Planning Board – December 18, 2017, 6:30PM
City Hall Council Chambers – 3 Washington Street, 2nd floor

SPR-13-17 SITE PLAN REVIEW – Eversource Substation Renovation, 0 Emerald St.

SPR-967, Mod. 8I SITE PLAN REVIEW – Monadnock Food Co-Op Expansion

Overall Site Plan

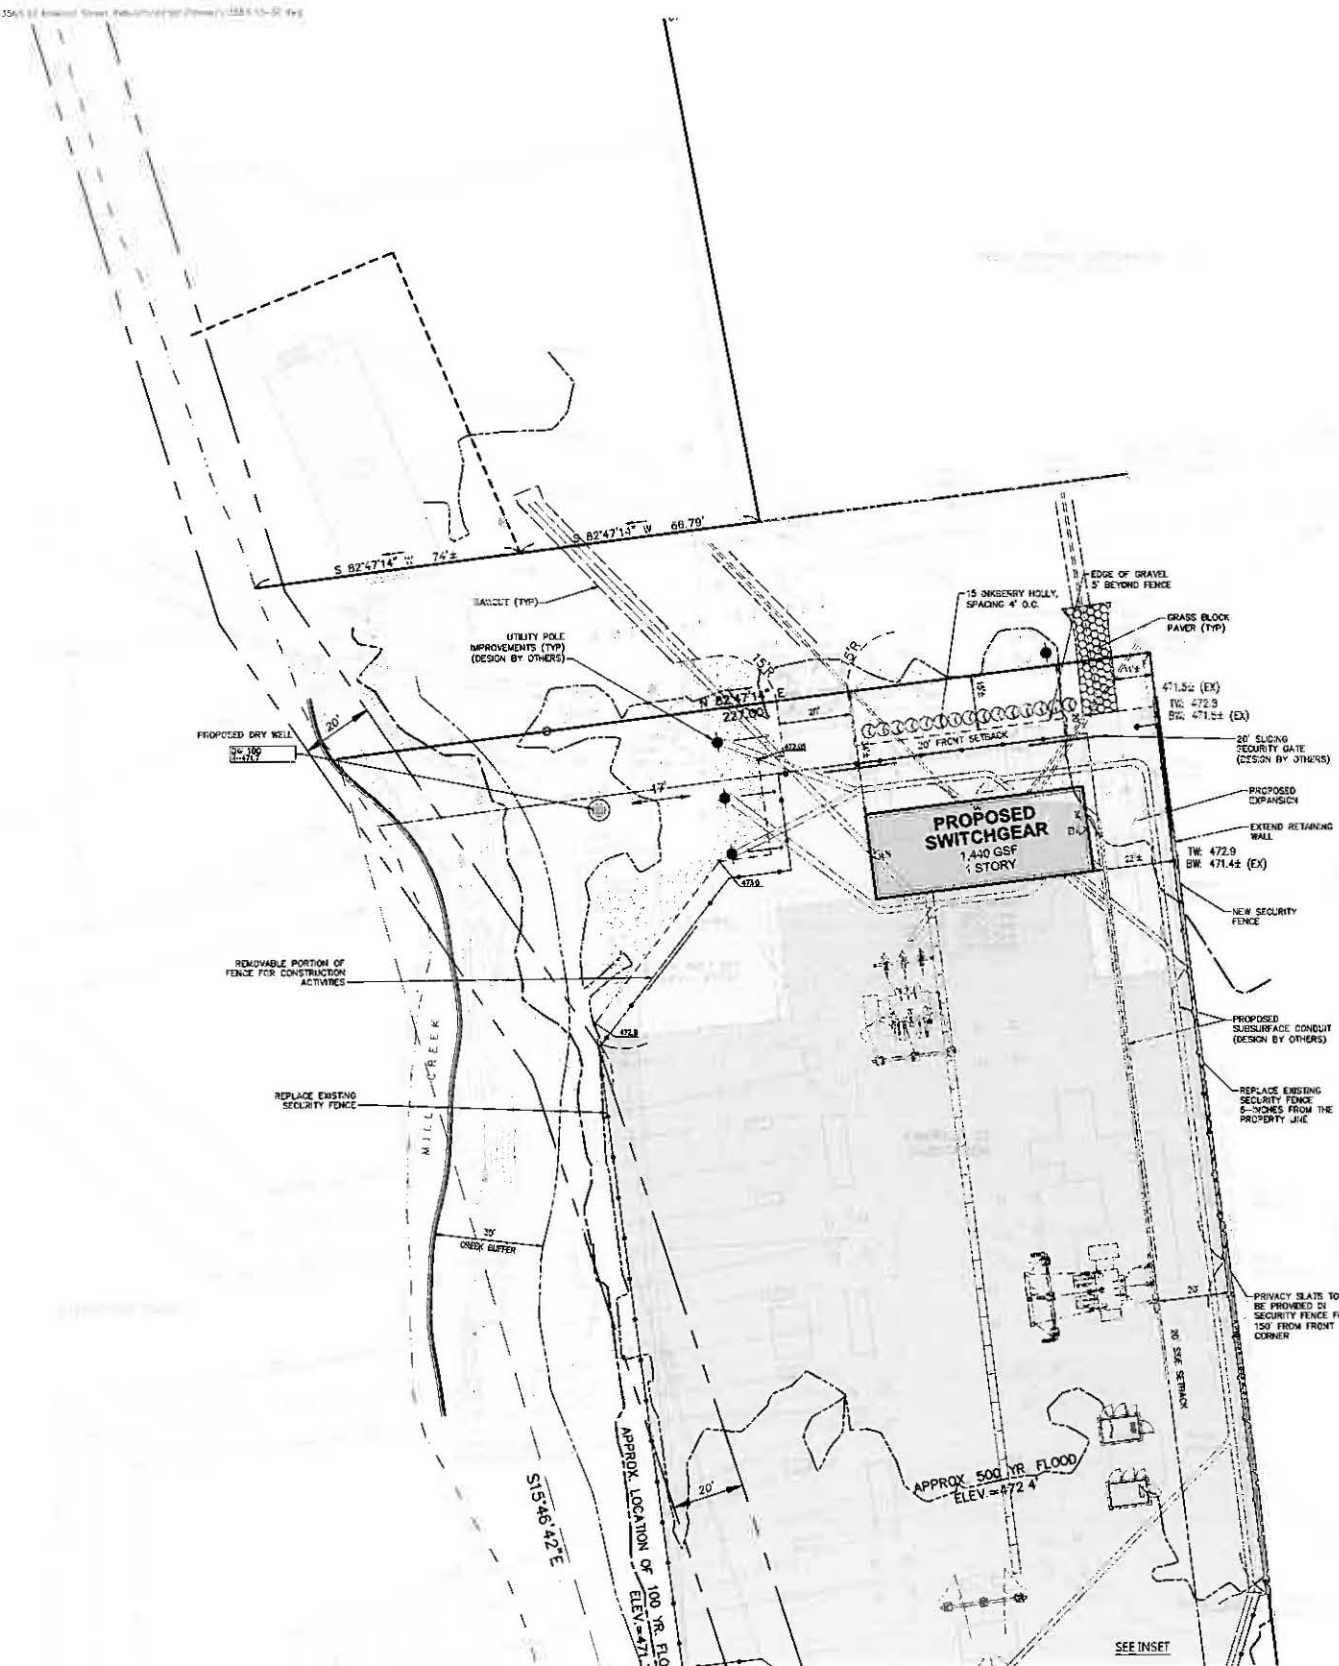
A meeting was held on December 5th, 2017 with the applicant's representatives, City Planning staff, Lieutenant Maxfield and Mr. Tousey to discuss the issue of screening alongside the eastern boundary of the subject property:

2. Proposed plantings on the north side of the proposed structure are now specified as 4' shrubs with an appropriate planting detail for such.
3. 150 LF of plastic slats are to be installed in the new, 8' chain link fence along the eastern property boundary. A note on the revised site plan now states: "Privacy slats to be provided in security fence for 150' from the front corner".

PROPOSED LANDSCAPE PLAN

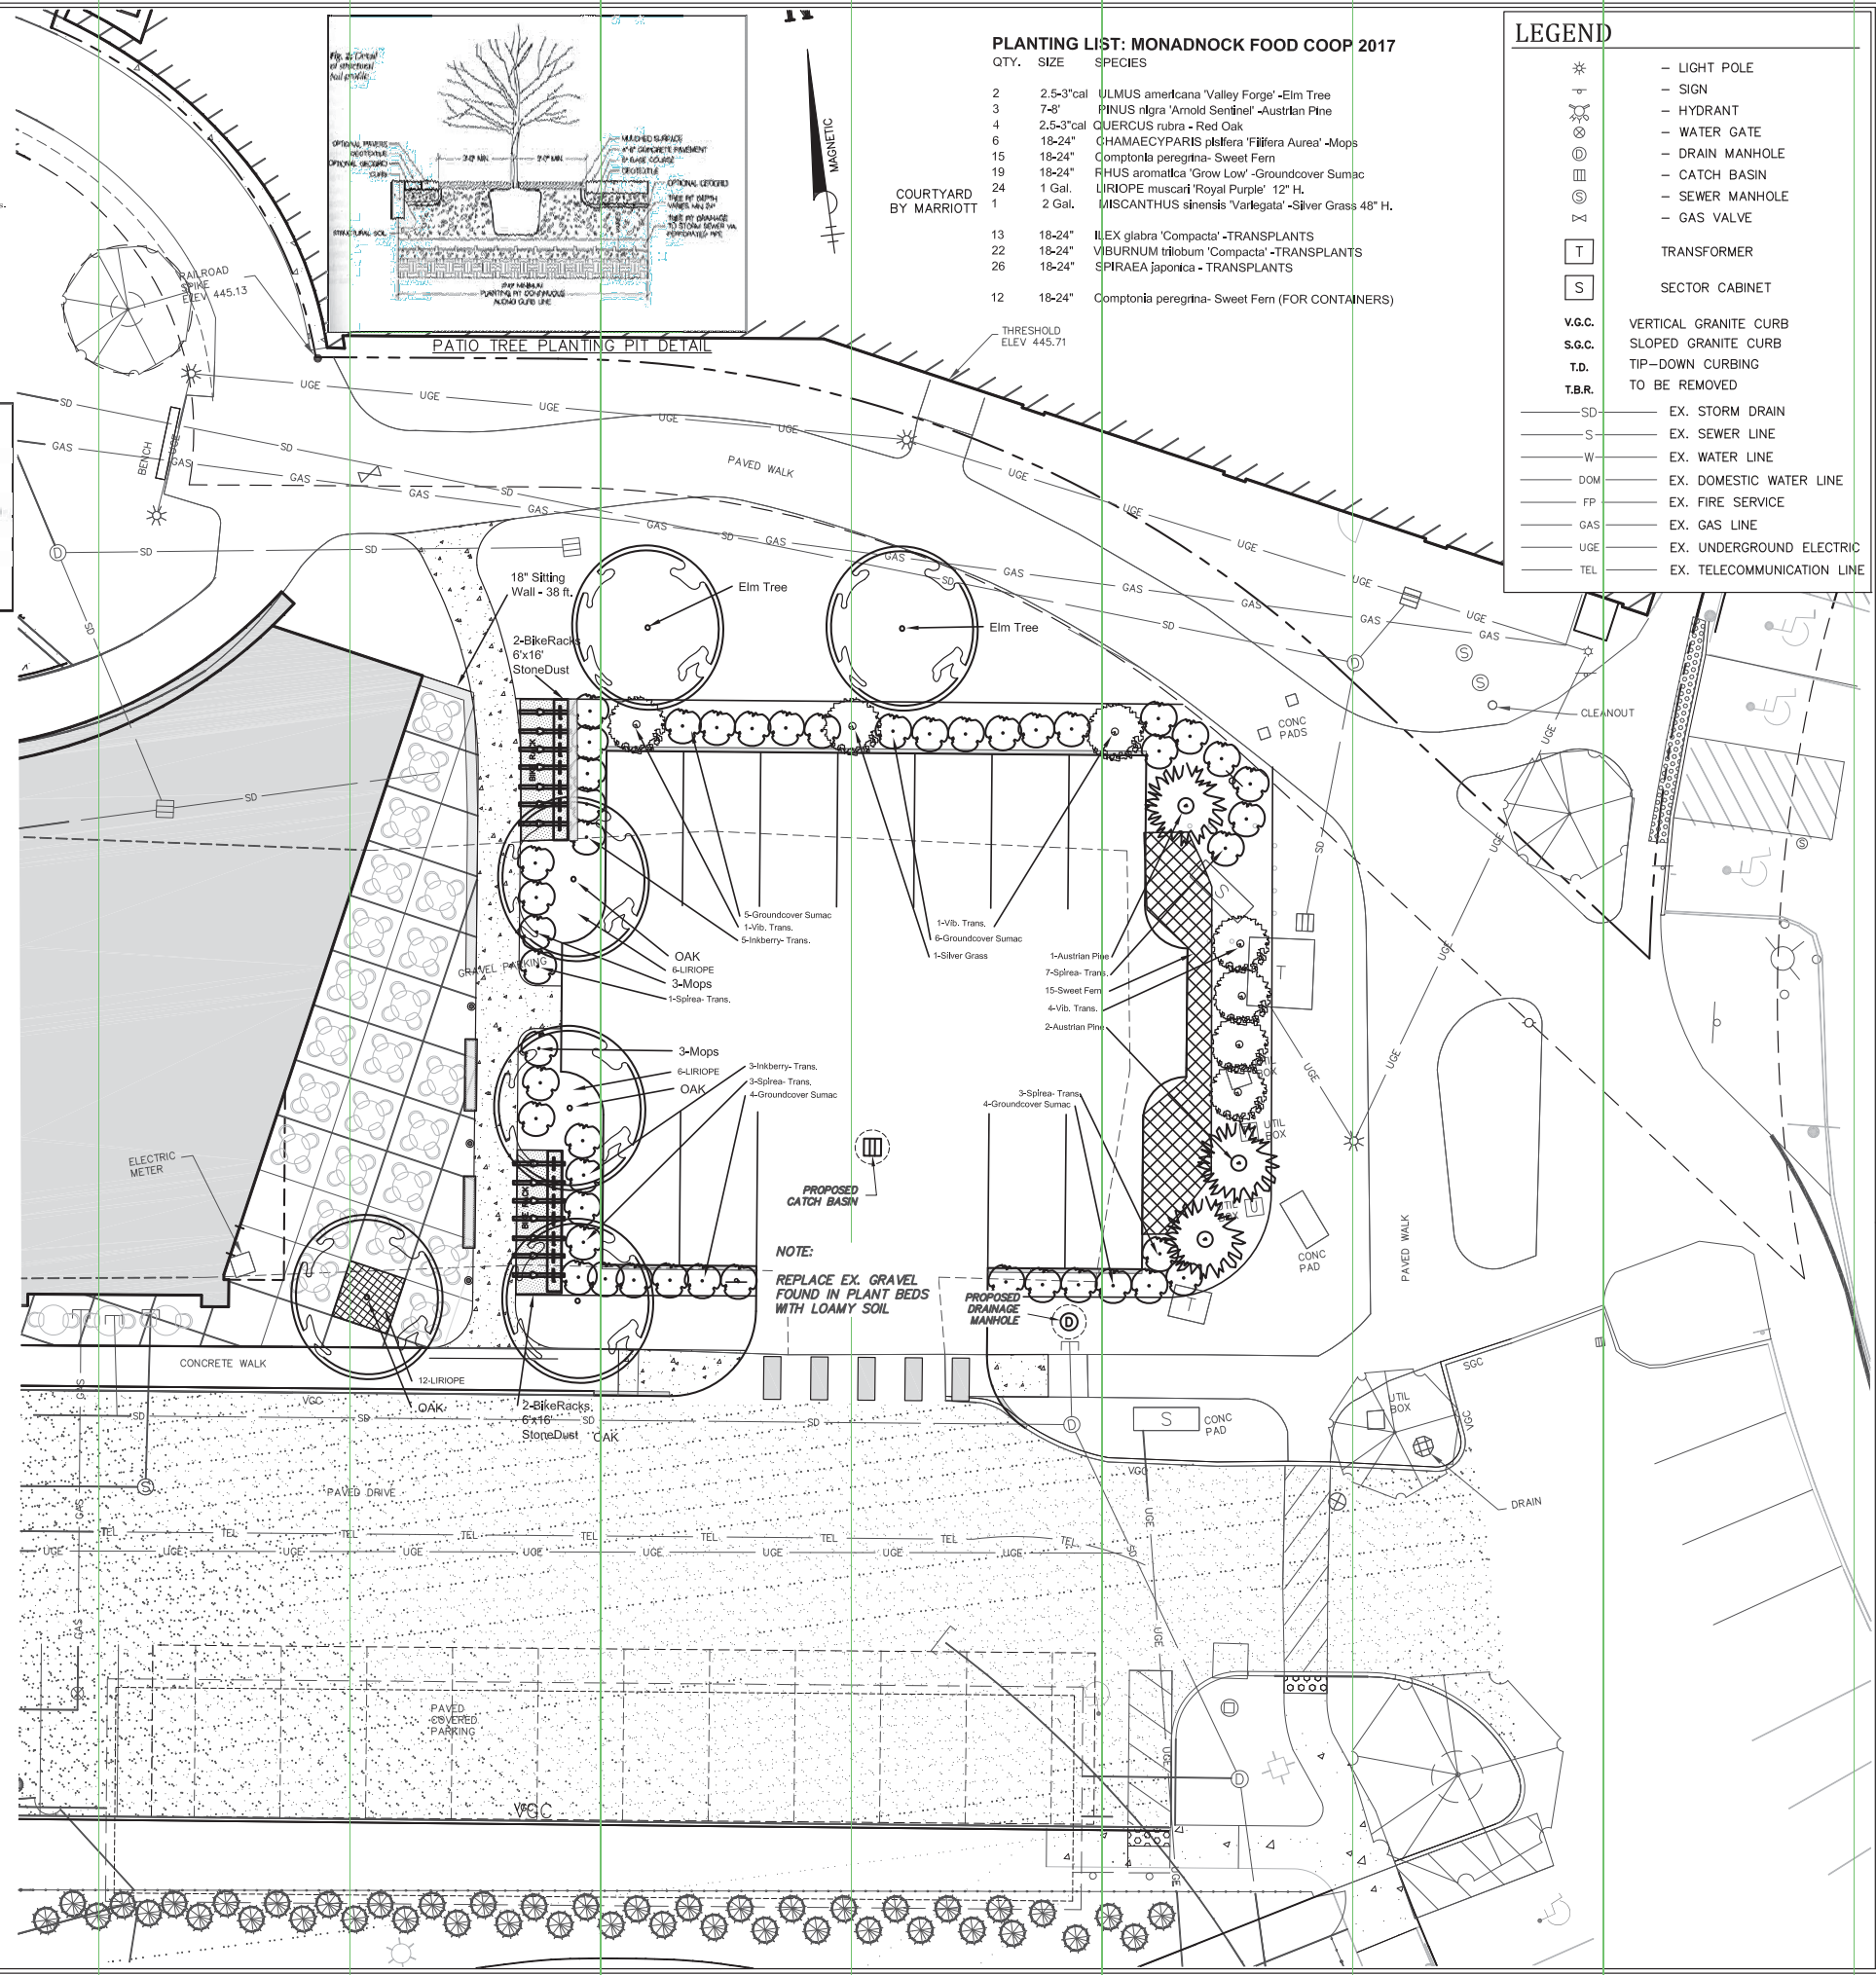
6. Landscaping: Per Planning Board Standard 6. the proposed site plan contains a variety of perennials, shrubs and shade trees. The applicant has revised the initially incomplete shade tree planting detail to include the required 300 CF of native soil for each shade tree. Additionally, given the predominance of gravel present on site with minimal topsoil, the applicant has also revised the standard shrub planting detail to require a minimum of 12” soil below each root ball. It should be clearly stated up front that these transplanted shrubs will also be subject to the City’s one-year planting guarantee.

8. Screening: Per Planning Board Standard 8. the landscape plan shows the transplanted shrubs will provide screening from the adjacent parking lot. This standard has been met.
